**September 26, 2025
Addendum #2
FOR IMMEDIATE ATTENTION**

Reference – Invitation for Bid:	IFB #003-0-2026/SB
For Delivery To:	Menchville High School HVAC System Replacement
Bids Due:	Newport News Public Schools October 7, 2025 at 2:00 PM EST

ADDENDUM NO. 2

**HVAC Replacement
Menchville High School
Bid # 003-0-2026/SB
Newport News, Virginia
TCE #23-065**

E-002

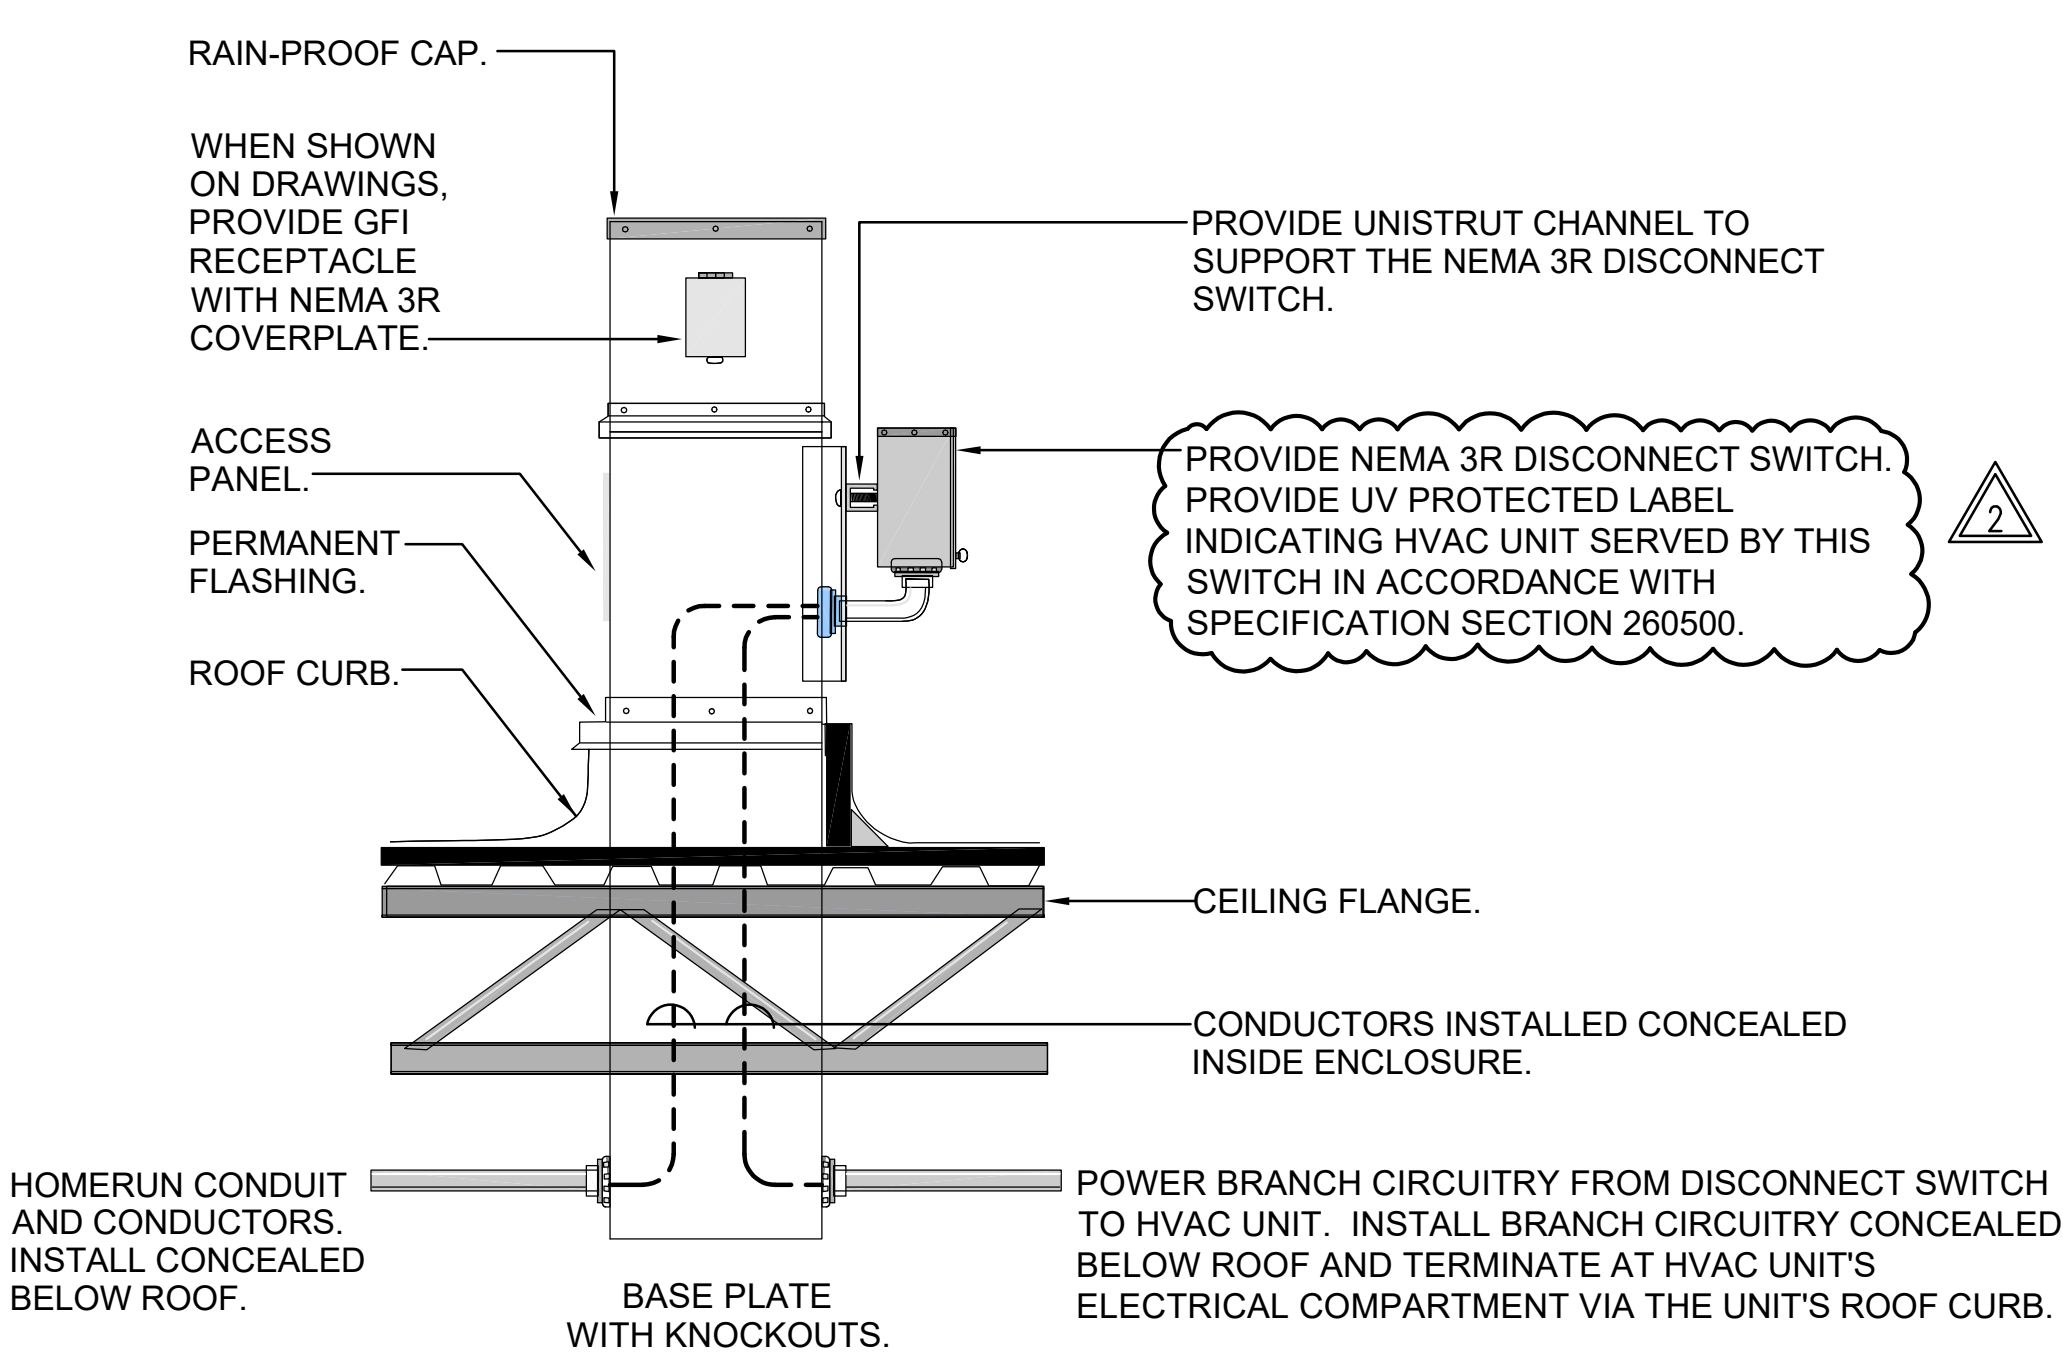
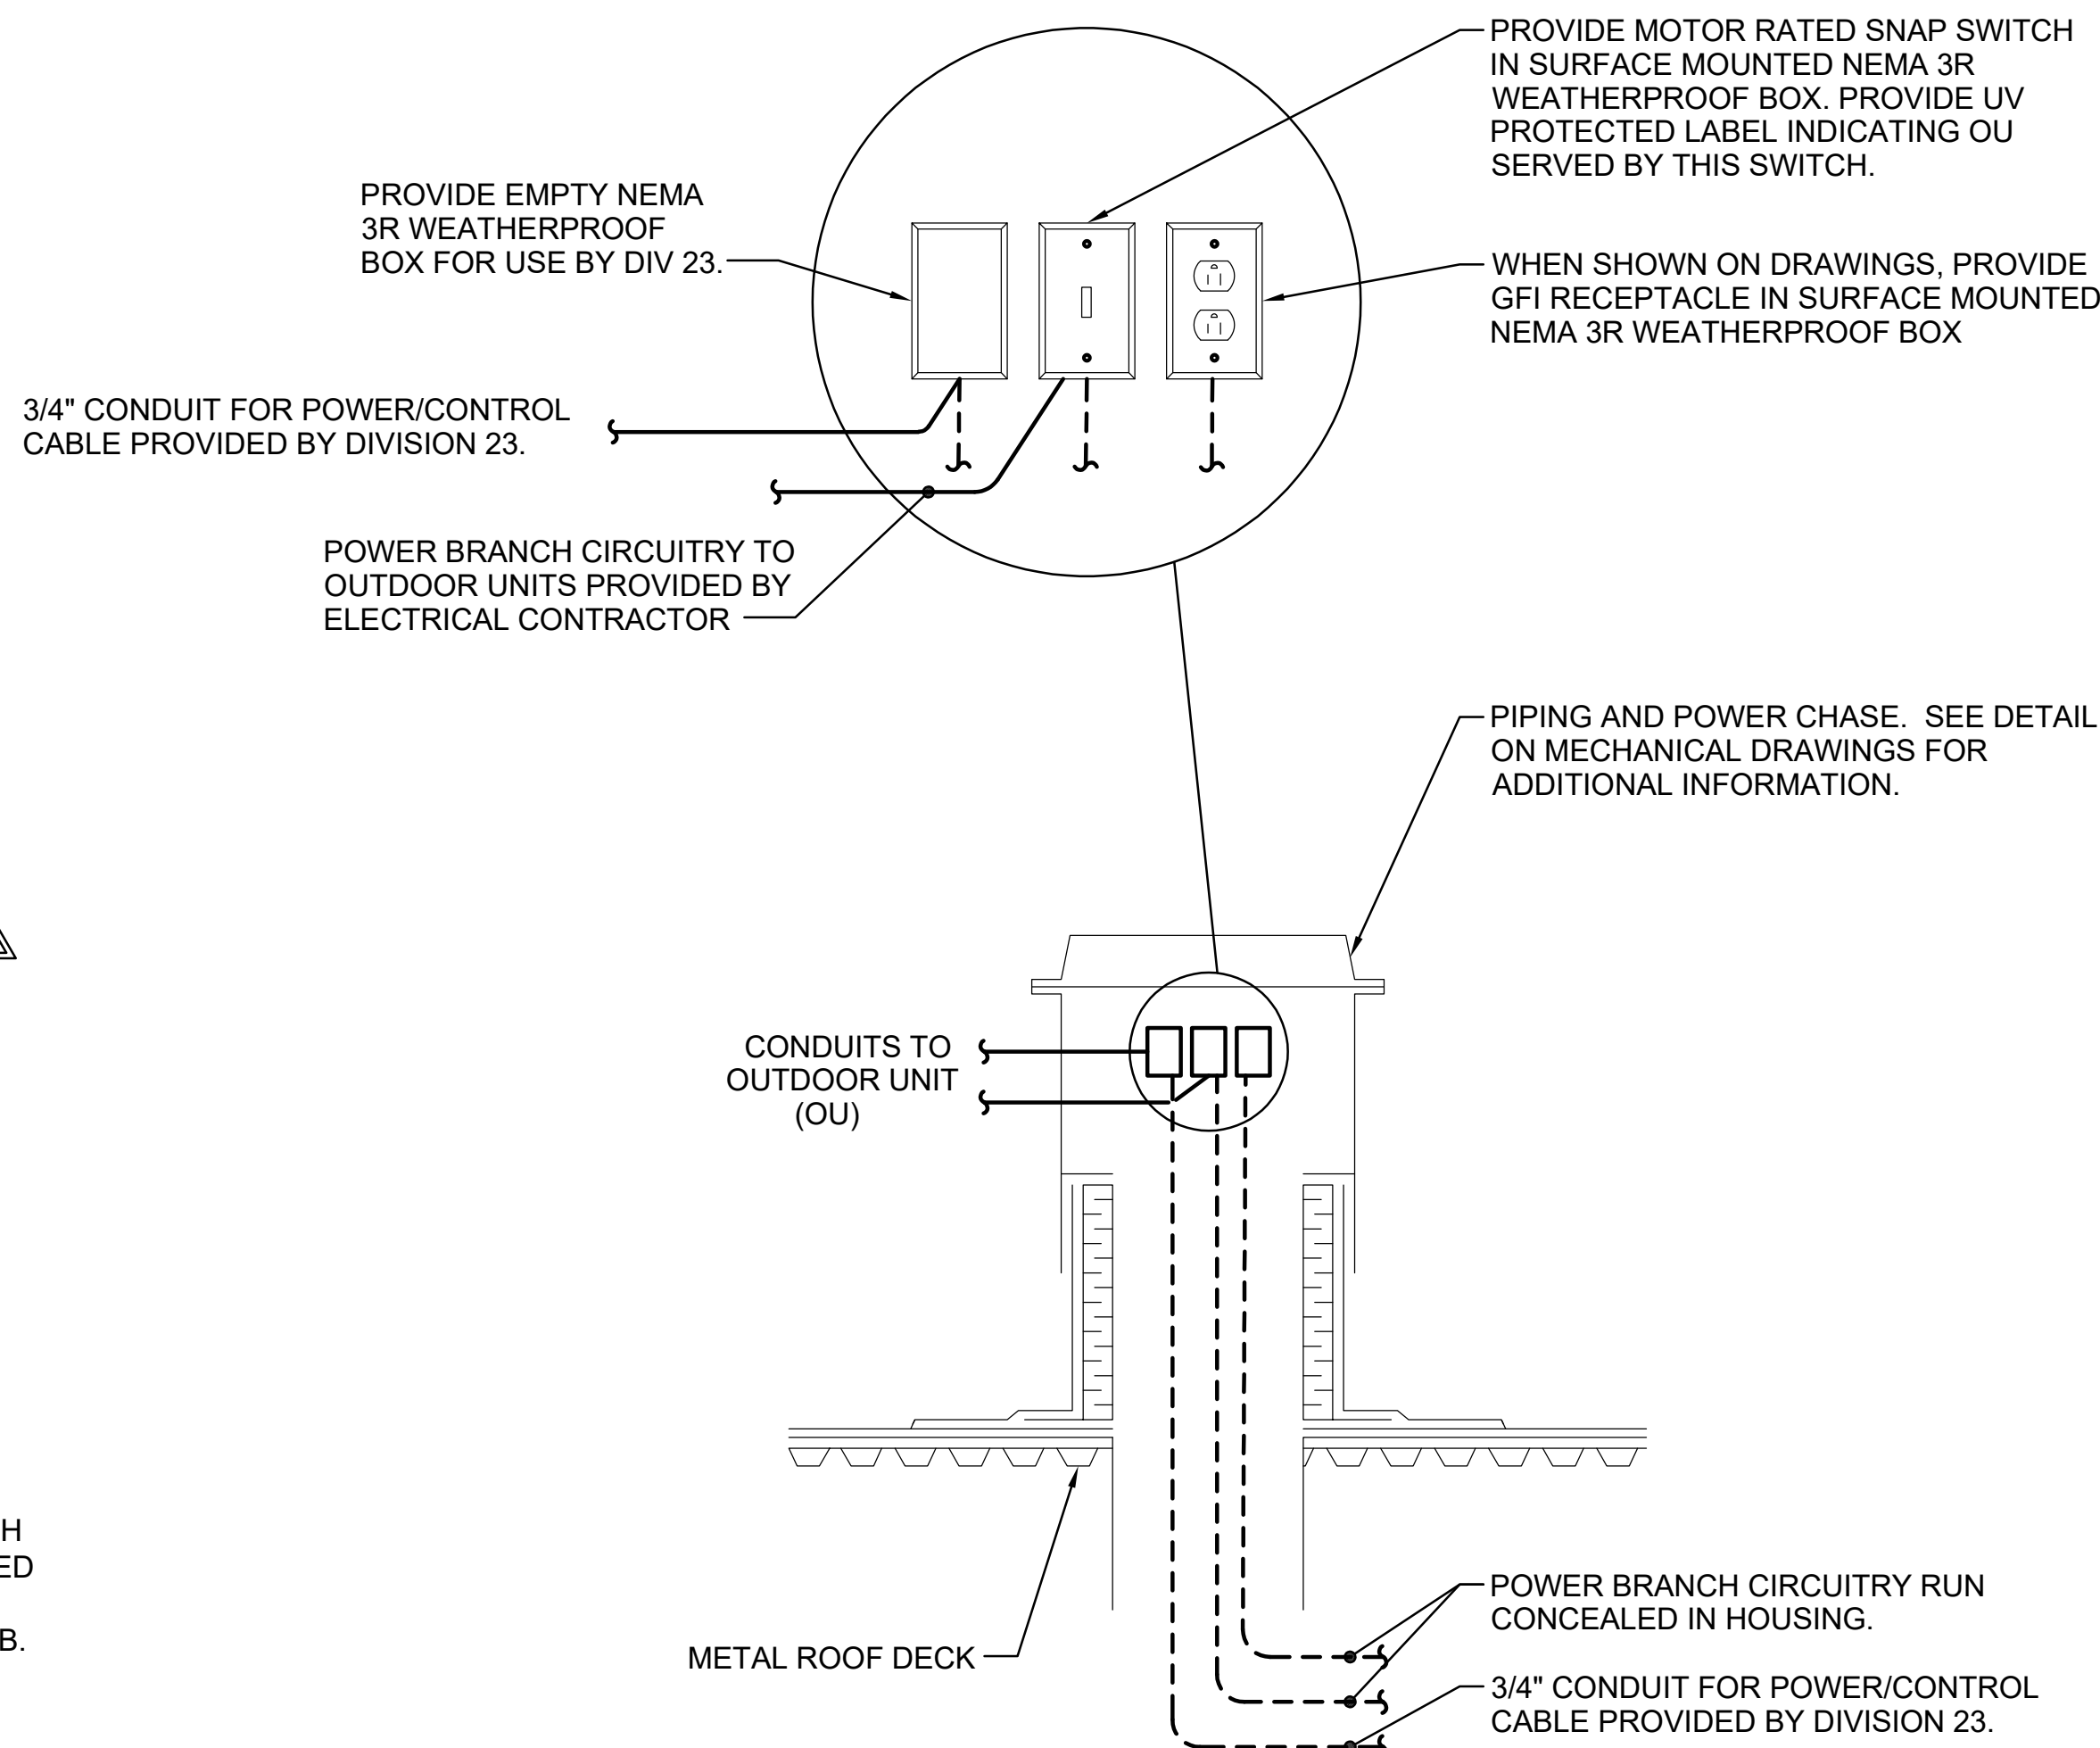
Sheet E-002:

- **CHANGE** Panel “BR1” to Panel “BR3”.
